**RE: Multi-Specialty Clinic
Grading and Drainage Plan
Engineer's Stamp Date 11-20-2015 (File: M15D026B)**

RE: Multi-Specialty Clinic Grading & Drainage (File M15-D026B)

Please find the following responses addressing staff comments from correspondence dated July 18, 2015 listed below:

MULTI-SPECIALTY CLINIC 2901 TRANSPORT ST, S.E. STORM DRAIN PLAN AND PROFILE	DRAWN BY DY
		DATE 11/06/15
	SHEET # SD-1	2015044-SD
		JOB # 2015044

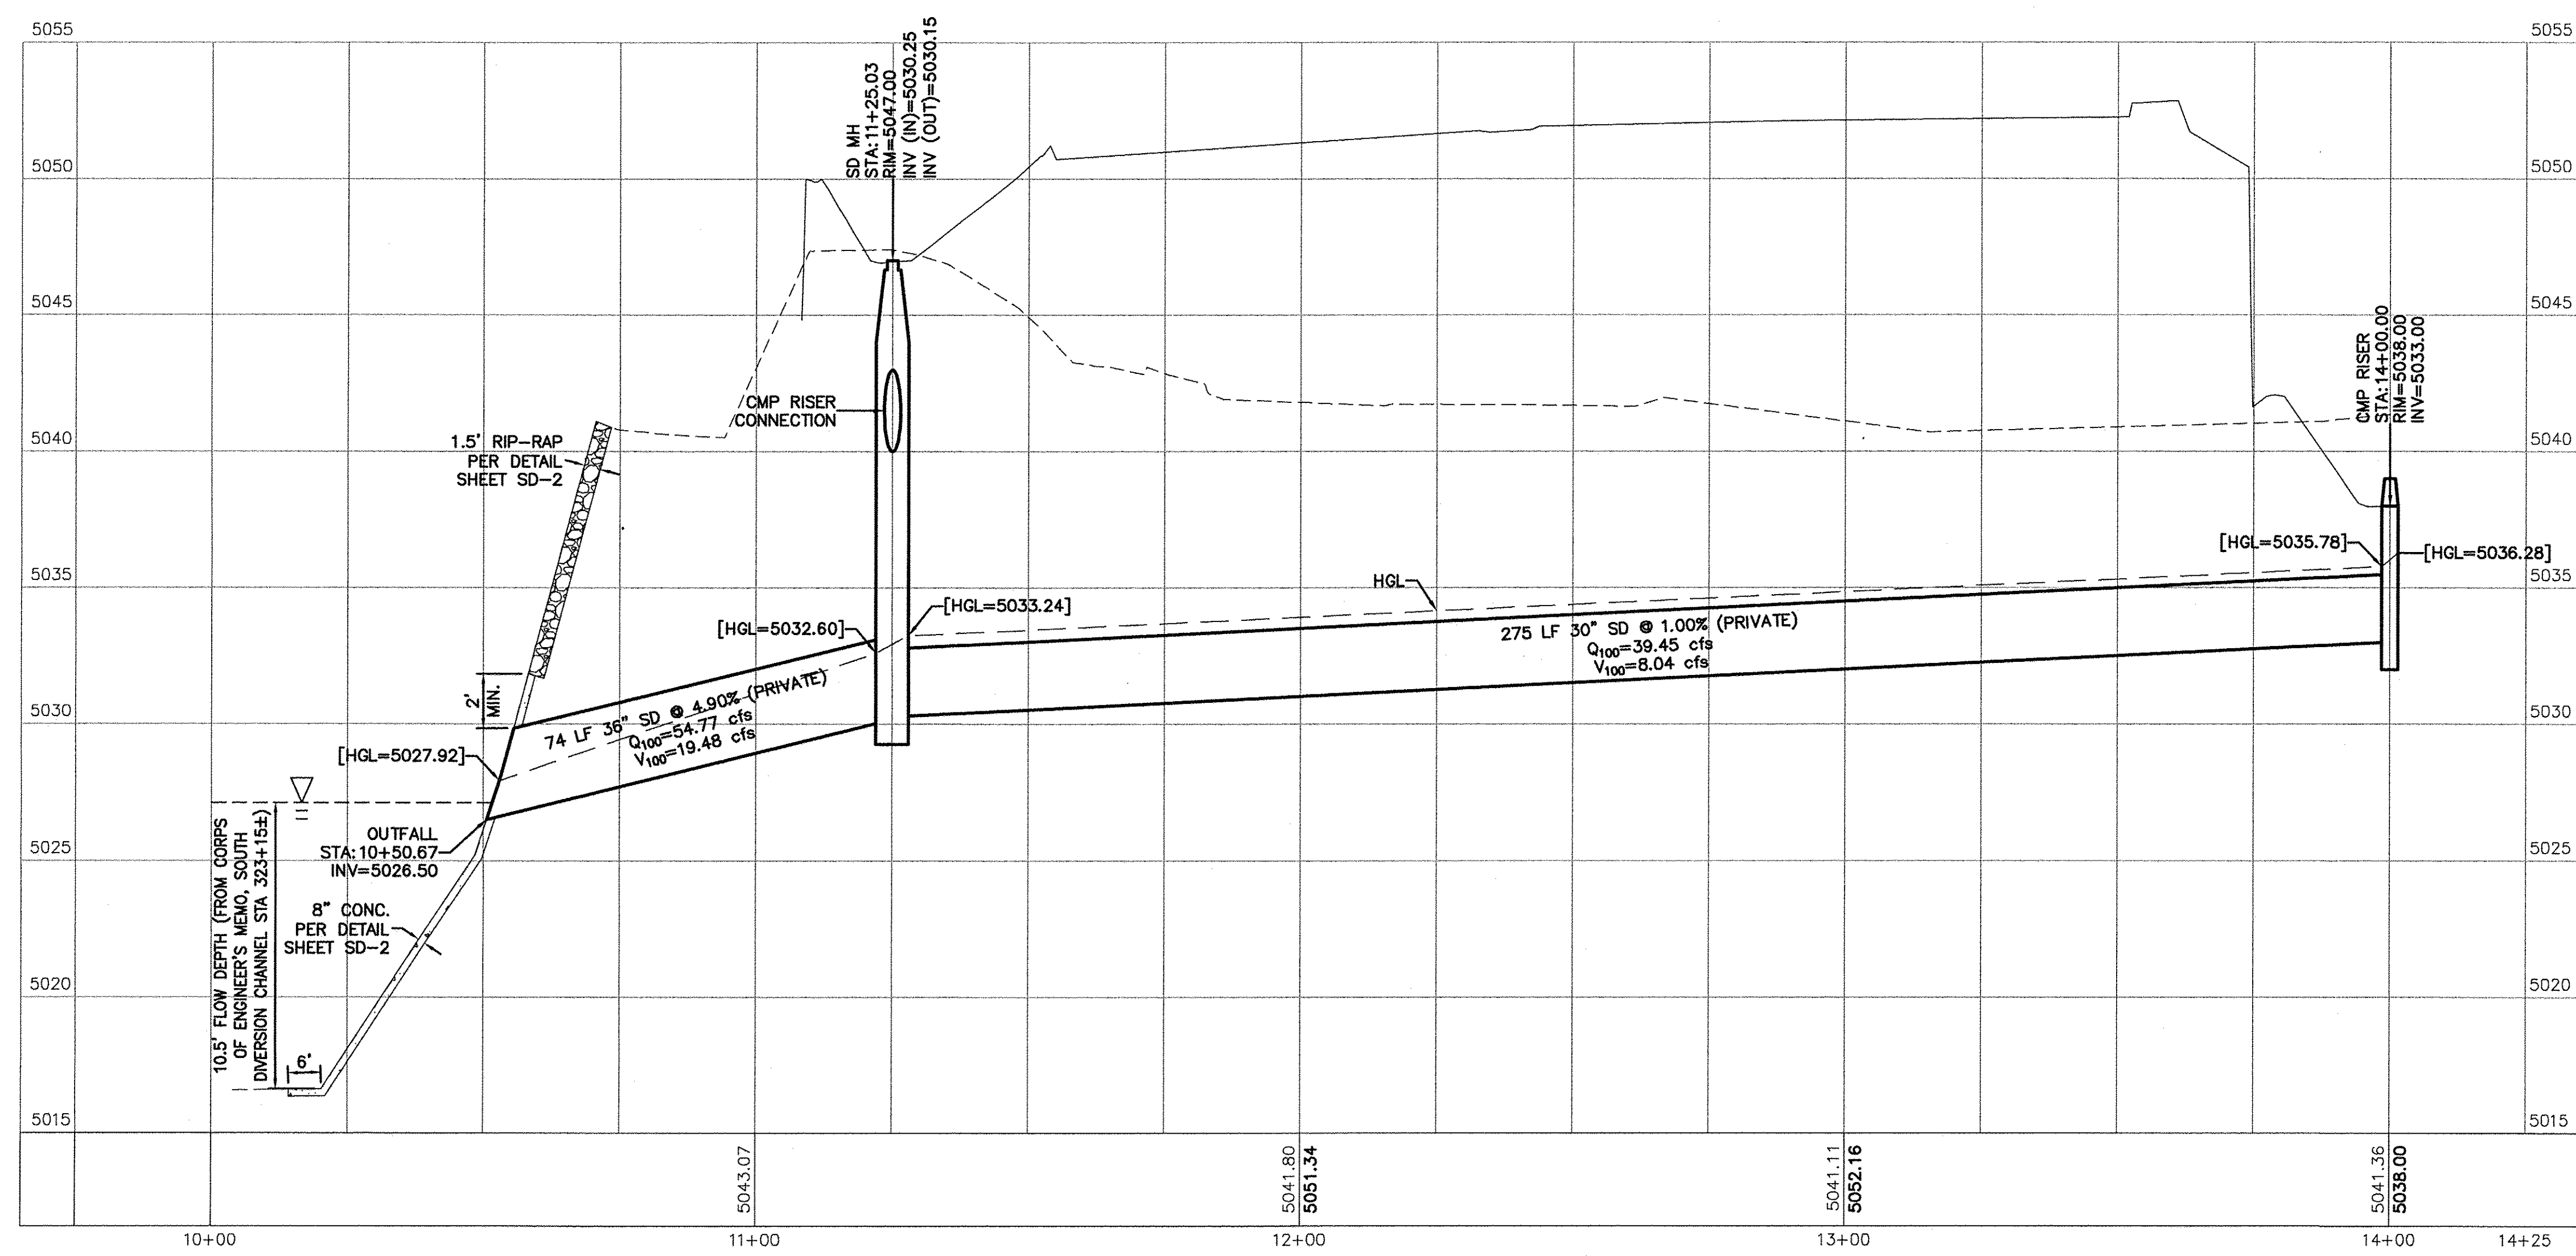
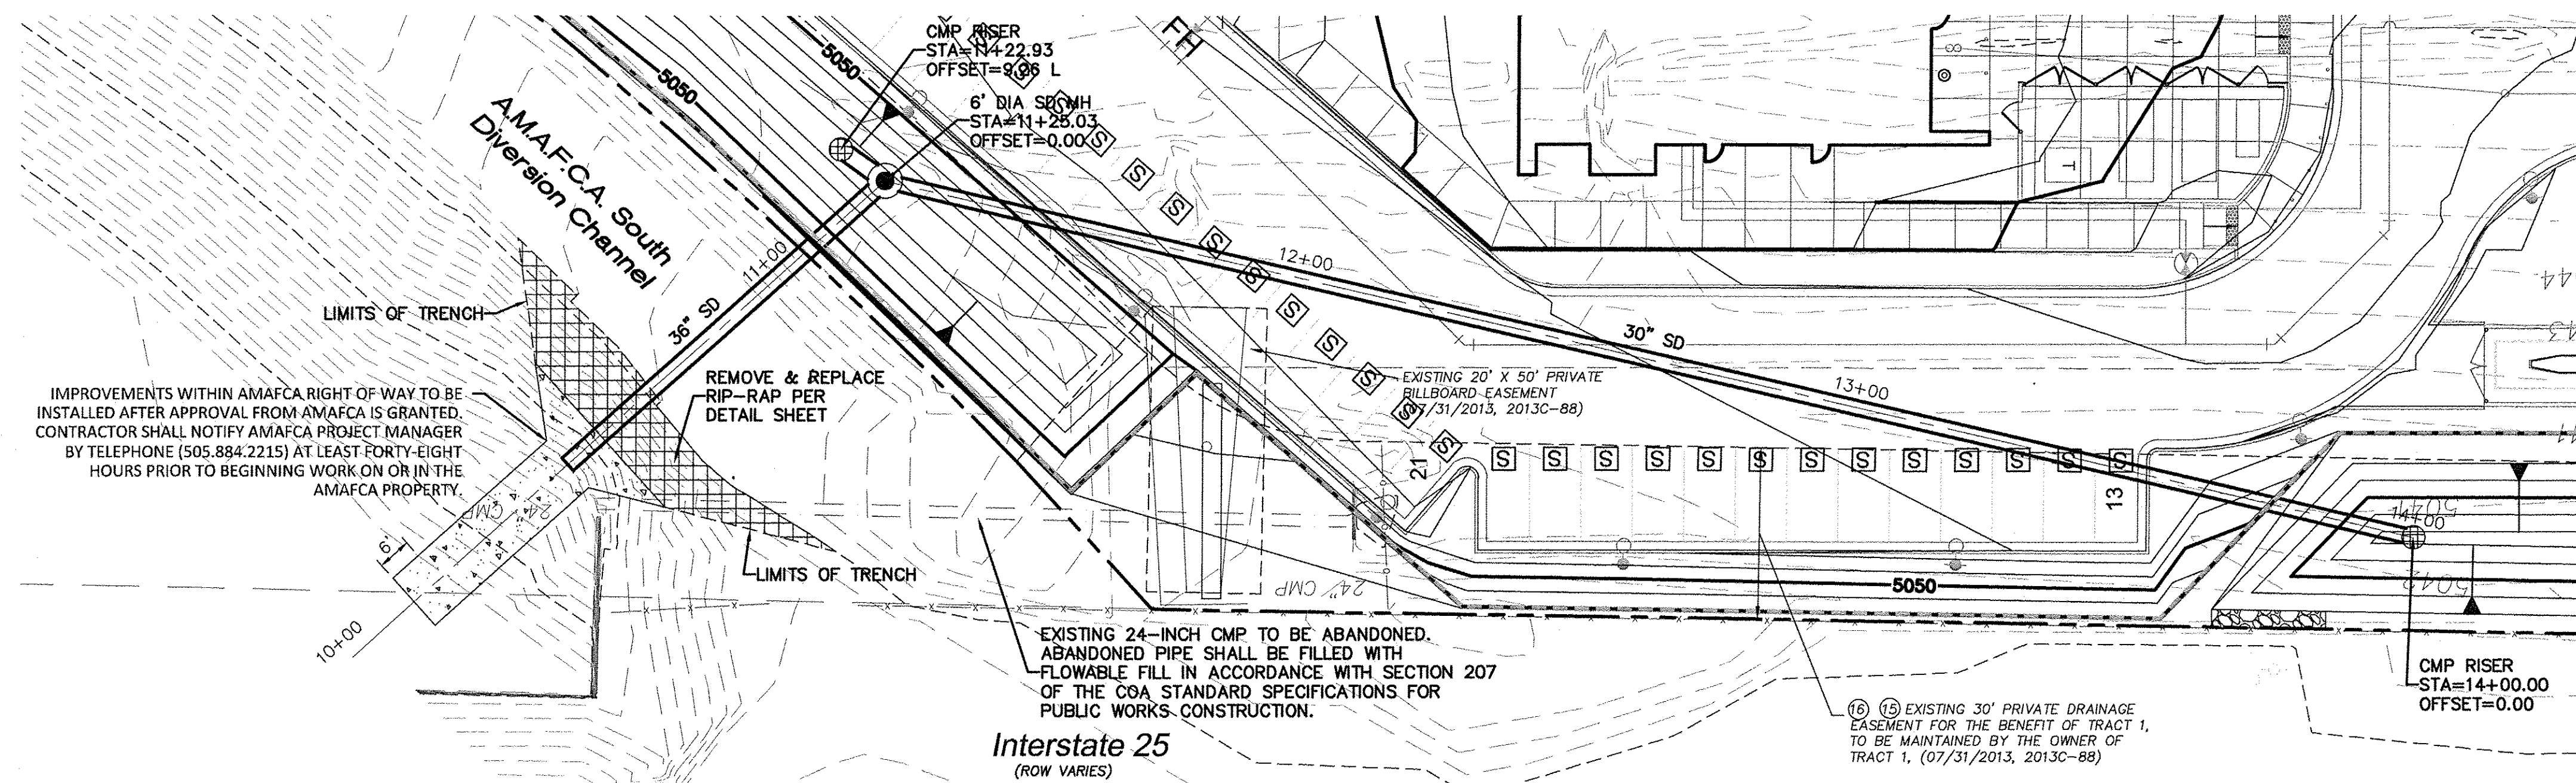
3. Show the HGL and Q on the storm drain profiles for the storm drain network that outfalls to The Diversion Channel.

11. Has coordination with the USACE been completed per AMAFCA's review letter of the Capstone Student Housing Drainage Management Plan (letter dated June 25, 2013)?

Response: We have updated the storm drain profile sheet to include the HGL and Q, as requested.

Response: The review with the USACE is ongoing, but is limited to the construction of the outfall improvements. We have added a note to the storm drain plan (SD-1) requiring this work proceed upon and until approval is obtained from the USACE and authorization from AMAFCA. The work within the AMAFCA right of way is subject to executed license agreement which requires adherence to the approved plans and notification of the AMAFCA Project Manager at least forty-eight (48) hours prior to beginning work on or in the AMAFCA property.
